REQUEST

Current Zoning: R-5 (single family residential)
Proposed Zoning: UR-2(CD) (urban residential, conditional)

Approximately 0.37 acres located at the southwest intersection of Parkwood Avenue and Harrill Street, east of Seigle Avenue.

The petition proposes to allow a single family attached (townhome) development with up to nine residential units on a parcel currently developed with a single family residence.

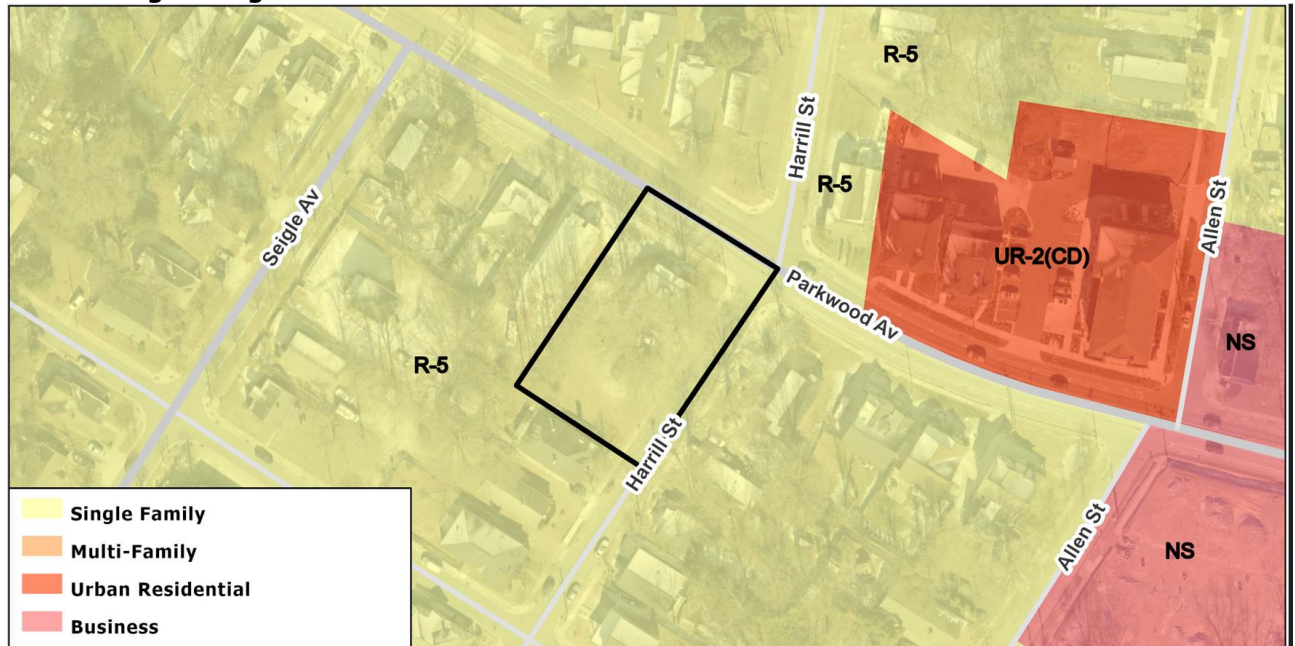
- ~~1. Curblin~~ The proposed zoning district has a setback measured from back of the existing or proposed future curblin. **ADDRESSED**
 - ~~a. Parkwood Avenue: Future back of curb and gutter to be placed 27 feet from Parkwood Avenue road centerline.~~ **ADDRESSED**

- ~~b. Label and dimension the curb and gutter from the centerline for each road on the site plan.~~ **ADDRESSED**
- ~~2. Label and dimension existing curblin measured from centerline of Parkwood Avenue. Show existing buffered bike lane (with dimensions) along Parkwood Avenue for CDOT to determine if existing conditions are to remain.~~ **ADDRESSED**

- ~~3. Site plan and conditional note(s) revisions are needed to commit to construct bicycle facilities by locating the curb and gutter 27 feet from the Parkwood Avenue road centerline and installing an 8 foot buffered bike lane along Parkwood Avenue to meet the City Charlotte BIKE Policy.~~ **ADDRESSED**

-
4. ~~A site plan note(s) specifying dedication and fee simple conveyance of all rights of way to the City before the site's first building certificate of occupancy is issued as needed. CDOT requests rights of way set at 2' behind back of sidewalk where feasible.~~ ADDRESSED
5. ~~Update conditional note to include a 2' sidewalk utility easement (SUE) instead of 1' to match site plan.~~ ADDRESSED

6. ~~Tree save must be comprised of existing trees. If replanted tree save must be done at 150%. Area shown on plan does not have existing trees. More tree save than what is shown would be required.~~ ADDRESSED

7. ~~Provide more clear architectural details on how Building 5 will interact with Harrill St. Need to define treating portions of the building as a front versus a side through things like a wrapped porch, door placement, or other design elements.~~ ADDRESSED
